UT to Town Creek Restoration Project – Option A Final Monitoring Report/Closeout Report

DMS Project ID Number – 94648; NC DEQ Contract No. 003277

Submission Date: January 2021

Subject: Response to DMS Comments for DRAFT Monitoring Year 5 Report
UT to Town Creek Restoration Project – Option A
Yadkin River Basin – CU# 03040105 – Stanly County, NC
NCDMS Project ID No. 94648; NCDEQ Contract No. 003277

Figure 3. Cross-sections with Annual Overlays
UT to Town Creek Restoration Project - Option A: Project No. 94648

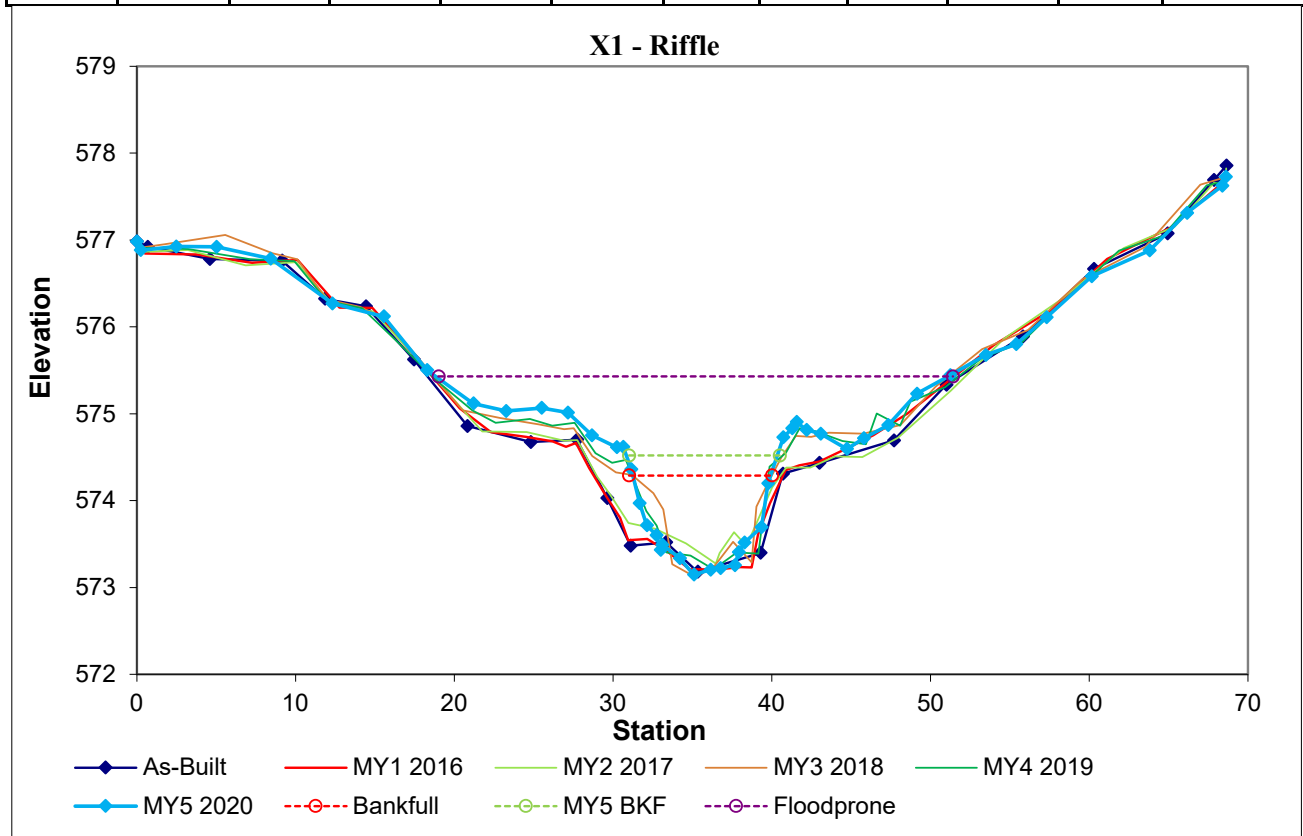
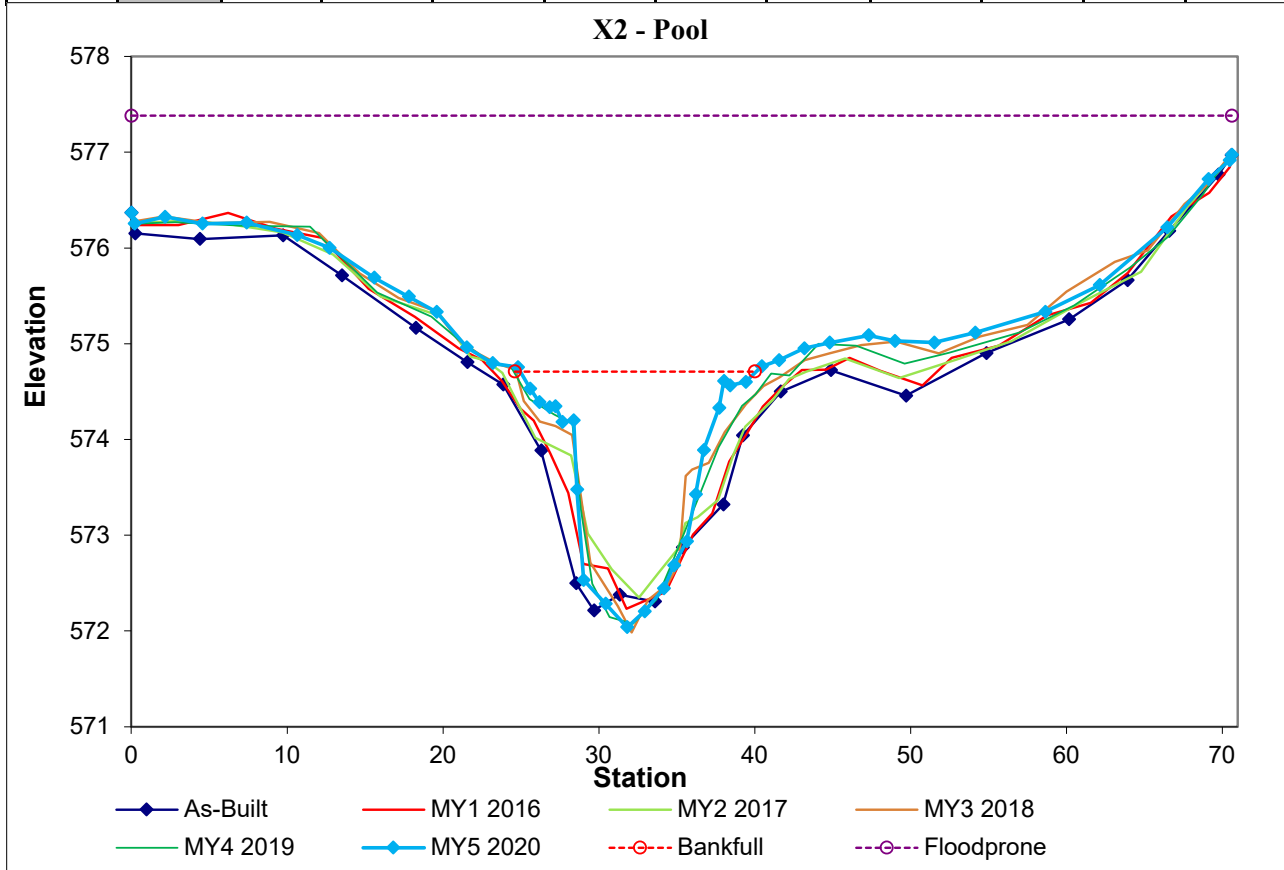
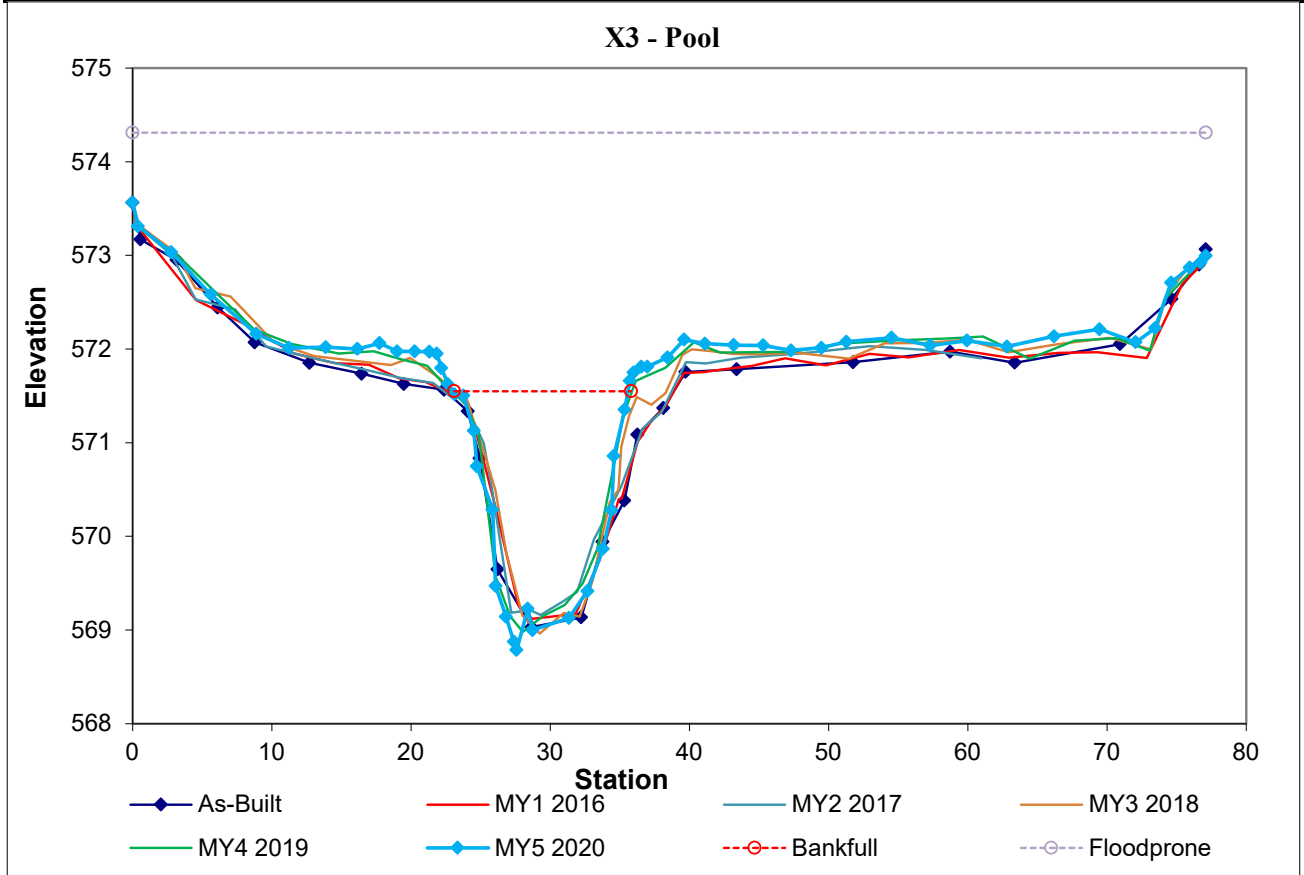
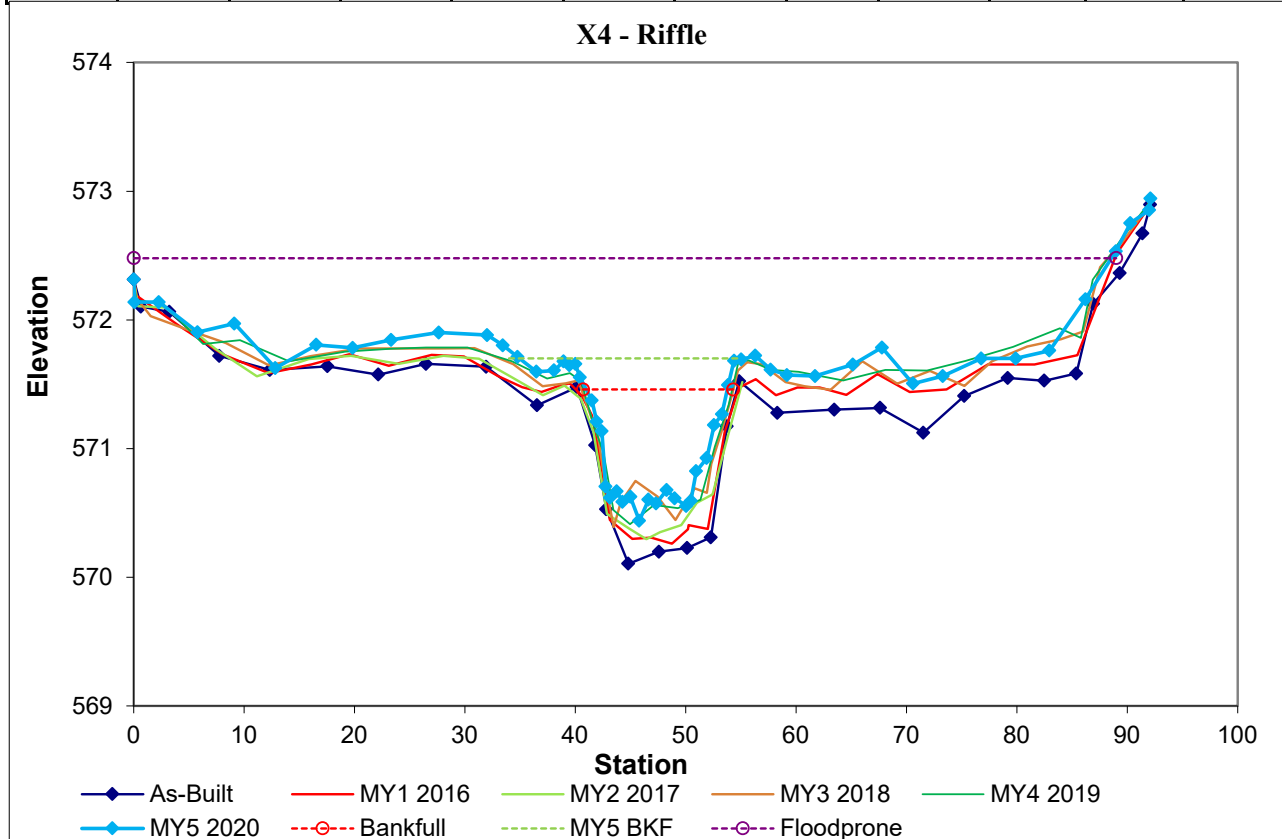
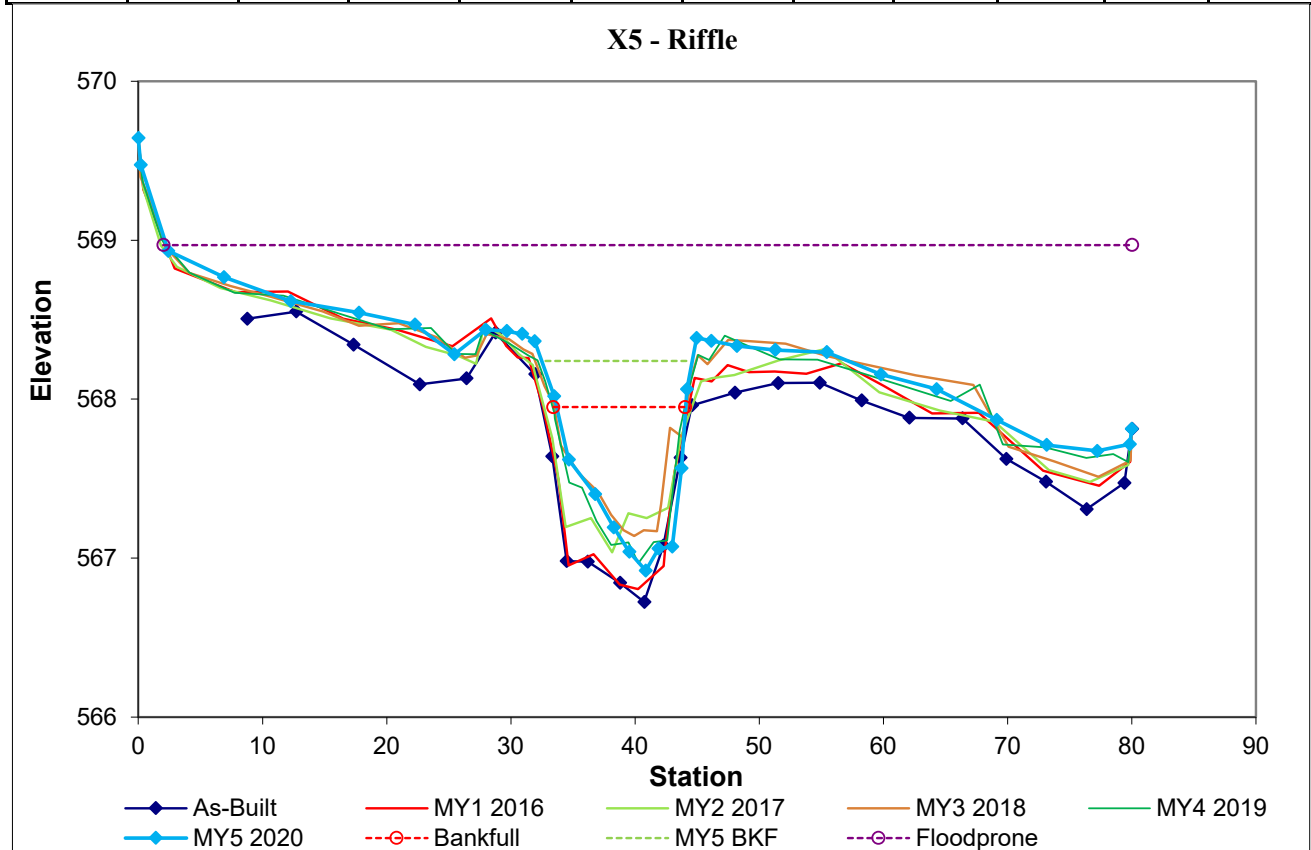
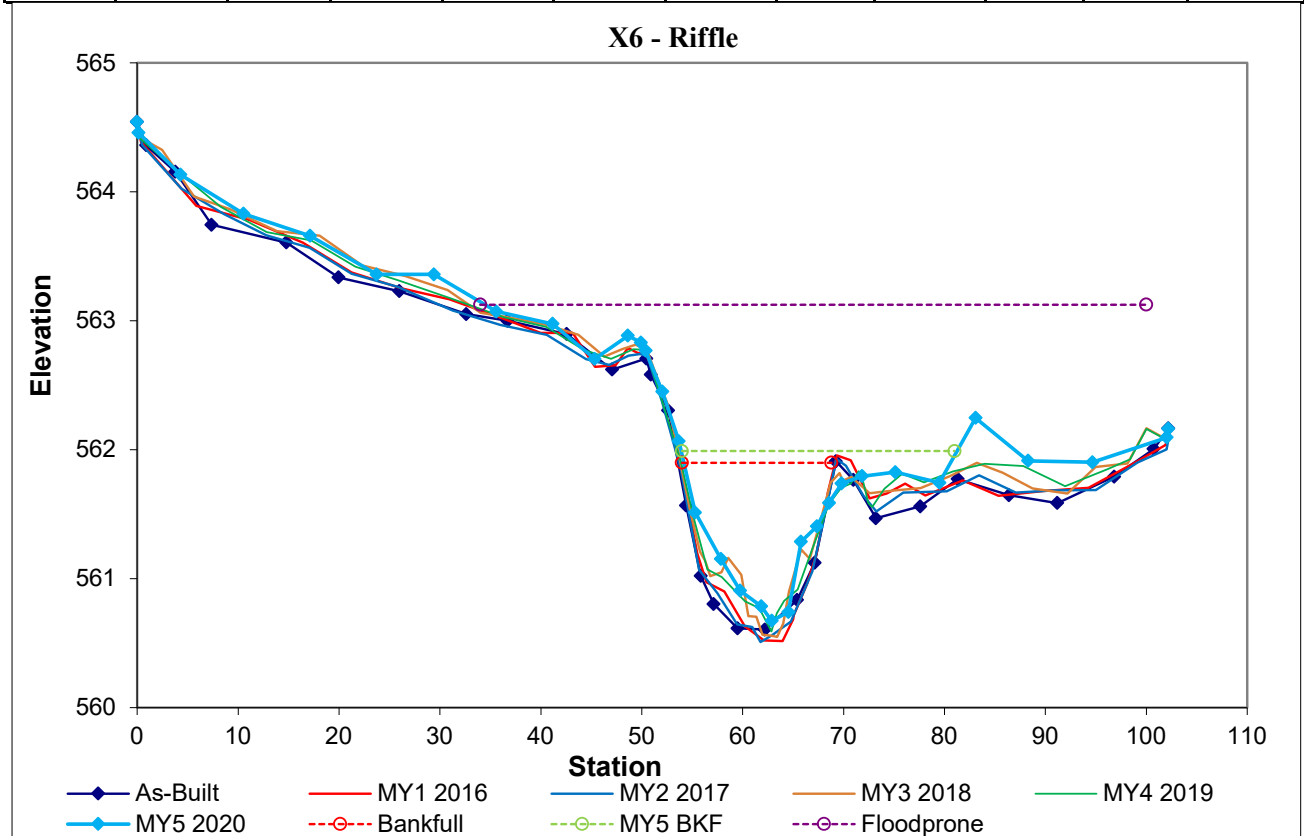
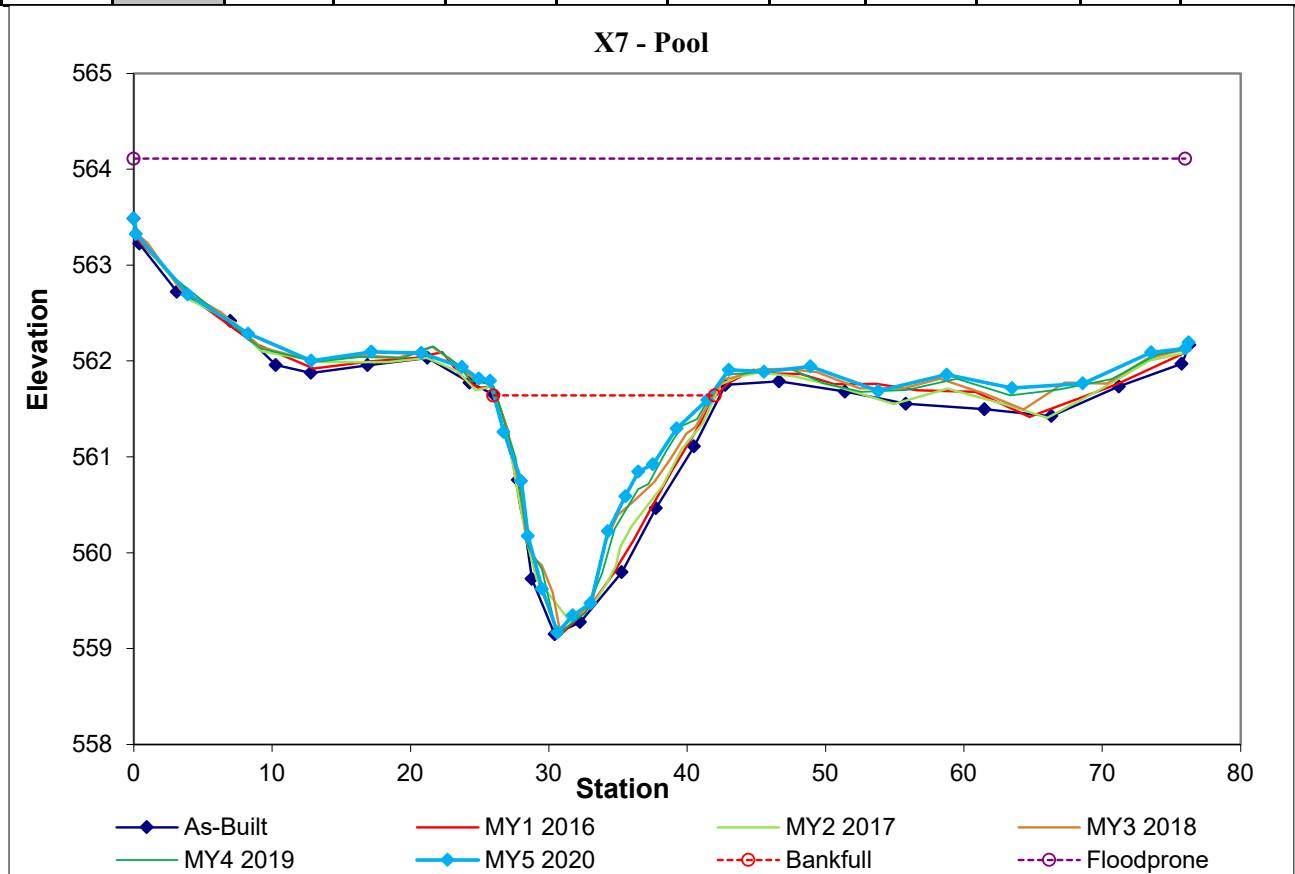
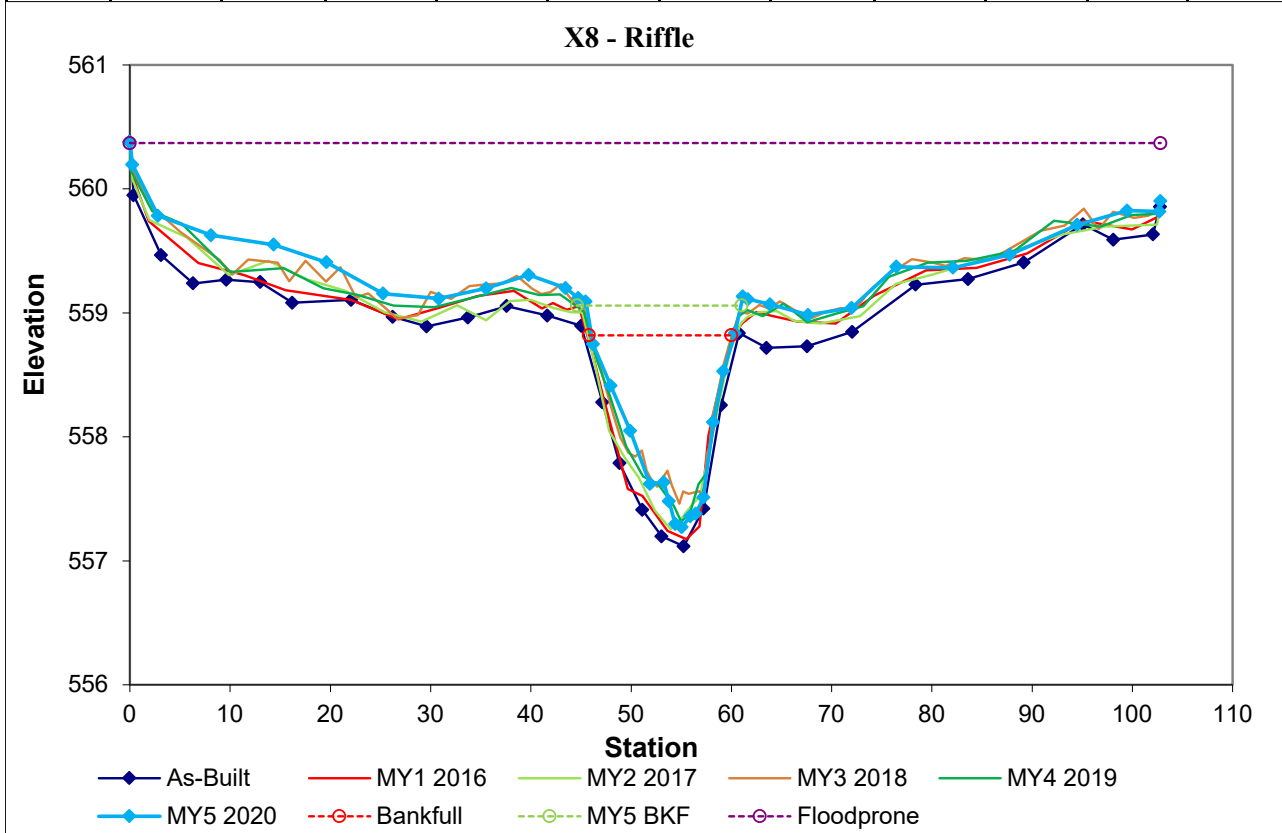
- *Please be sure that all cross section calculations are using MY5 data, and verify that the data being used in the BHR calculations are accurate. For example, it appears that XS 1 is still using MY4 data based on cell N29, while the XS 13 LTOB is listed as 565.3, but it is 565.057. The BHR calculations should be using the current monitoring year's low top of bank depth in the numerator, and in the denominator the depth at the elevation that achieves the MY0 cross sectional area in the MY5 channel should be used.*

Response: Revisions have been made to figure 3 and table 11a and 11b per DMS request.
